Validation report form for Project activity

VALIDATION REPORT

Title of the project activity	Biolite Solar Lighting Project in Malawi GS11397
Version number of the validation report	01.1
Completion date of the validation report	23/01/2024
Version number of PDD to which this report applies	Version: 05; Dated: 02/01/2024
Project Developer	Biolite, Inc
Project Participants and any communities involved	Swiss Carbon Value Ltd
Host Party	Malawi
SDG Impacts:	<ol style="list-style-type: none"> 1. SDG 1: No poverty (1.1) 2. SDG 7: Clean, Affordable Energy for all (7.1) 3. SDG 13: Climate Action (13.3)
Sectoral scope(s) and selected methodology(ies)	Sectoral Scope: 1 CDM Methodology: AMS-I.A. Electricity generation by the user - Version 19.0
Estimated Sustainable Development Contributions	SDG 13: Climate Action- 18,630 tCO ₂ e SDG 1: No Poverty- 4,058,041 USD SDG 7: Clean, Affordable Energy for all- 240,000 Households
Name of VVB	E-0052: Carbon Check (India) Private Limited

Carbon waiver example: 'Biolite SHS Warranty Card'
 1st sale registration form in document : "SHX-11066102- Registration 20200917"

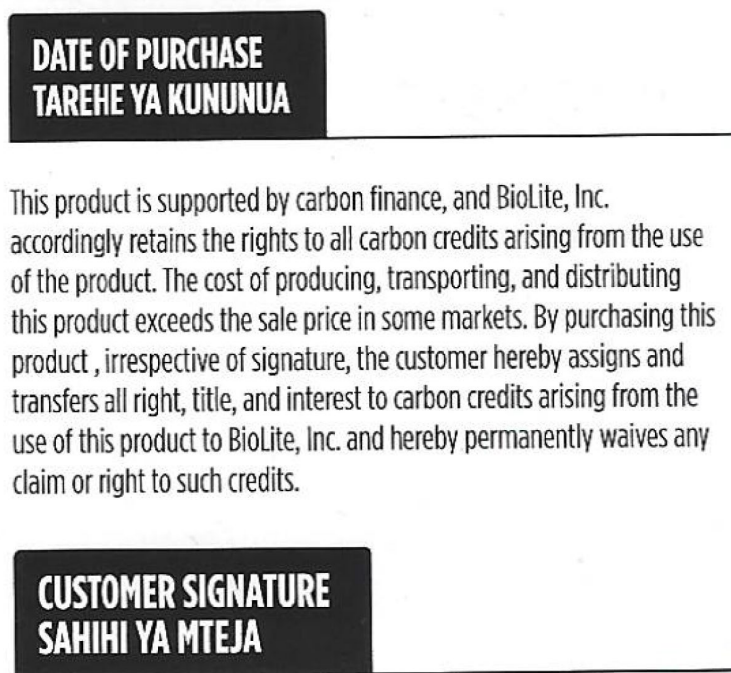
But However, PD has mentioned that "A carbon waiver, or consent form as part of the warranty (see document : 'Biolite SHS Warranty Card'), is signed by the user at the time of sale." VVB has referred the document "warranty card" as responded by PD however it is not traceable in the warranty card regarding the carbon waiver. Hence PD is requested to provide the specific document which has been signed by beneficiary. Hence the CAR is open.

None			
VVB assessment			Date: 01/12/2023
The warranty card submitted by PD explains the rights to carbon credits. Also, PD has submitted the 4 samples of the warranty registration card which is signed by the beneficiary. Hence the CAR is closed.			
CAR ID	07	Section no.	PDD Date: 27/06/2023
Description of CAR			
During the preliminary review of the PA, FAR#4 was raised by GS as follows: All the safeguarding principles assessment shall be supported with evidence/references/expert's opinion. The PD shall provide them for GS VVB validation			
PD response			Date: 09/08/2023
Expert opinion on highlighted safeguarding principles are found in document 'SGP assessment local expert SHS Malawi-Gracious' submitted along validation documents.			
Documentation provided by PD			
VVB assessment			Date: 22/08/2023
PD has submitted the 'SGP assessment local expert SHS Malawi-Gracious' containing the expert opinion on safeguarding principle assessment. Hence the CAR is closed.

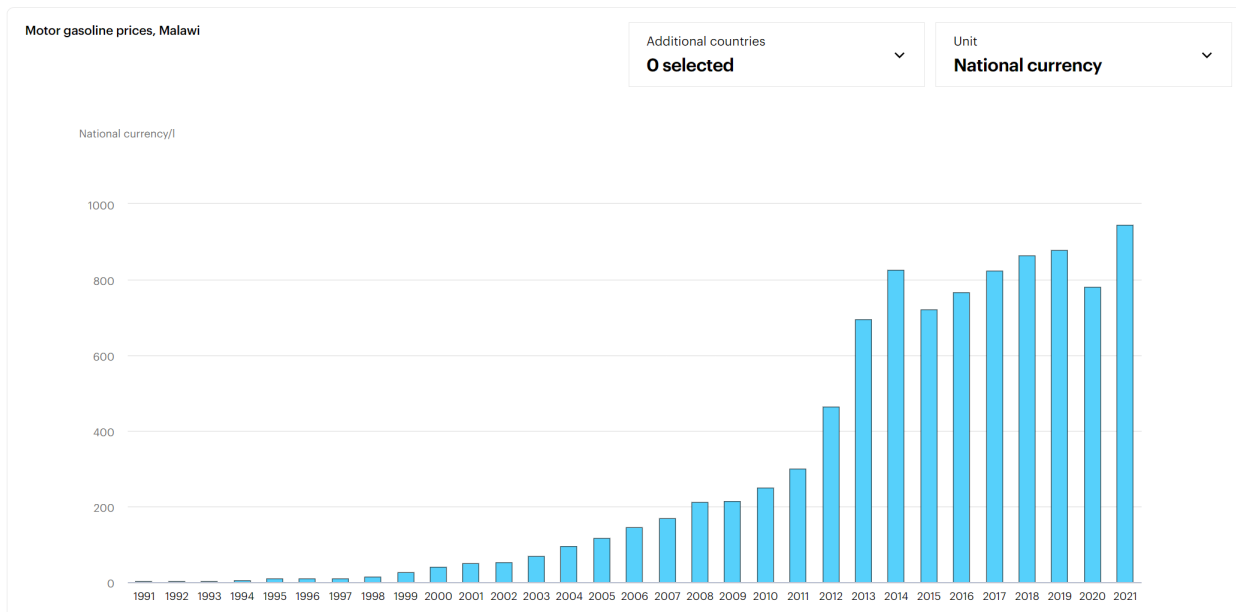
CAR ID	14	Section no.	PDD	Date: 27/06/2023
Description of CAR				
In the section A.3 of the PDD: <ul style="list-style-type: none"> • The maximum hours of 4 lights on HIGH for the model SHS620+ is inconsistent with the instruction manual provided by the PD. • Is not inline with the template filling form of PDD available in website. PD to include (ii) & (iii) mentioned under the section A.3 of the template filling form. 				
PD response				Date:
<ul style="list-style-type: none"> • In the instruction manual of model SHS 620+, it is mentioned that the device can run 6 hours of light with 4 lights on high. The same was presented in section A.3. VVB to clarify the inconsistency. <div style="text-align: center;"> </div> <ul style="list-style-type: none"> • Section A.3. was amended to include (ii) & (iii) items listed in the PDD guidelines template. 				
Documentation provided by PD				
"SH620+ InstructionManual"

<ul style="list-style-type: none"> The maximum hours of 4 lights on HIGH for the model SHS620 is inconsistent with the instruction manual provided by the PD. CAR is open. PD to provide response. CAR is open. 	Date: 25/10/2023
The maximum hours of light for model SHS620 is updated in the PDD to match the instruction manual.	
Documentation provided by PD	
Updated PDD	
VVB assessment	Date: 16/11/2023
<p>In the section A.3 of the revised PDD:</p> <ul style="list-style-type: none"> PD has now made the maximum hours if 4 lights on HIGH for the model SHS620 to be consistent with the instruction manual. The same is cross checked by VVB. Hence the CAR is closed. PD has now included (ii) & (iii) mentioned under the section A.3 of the PDD template filling guideline. <p>Hence the CAR is closed.</p>
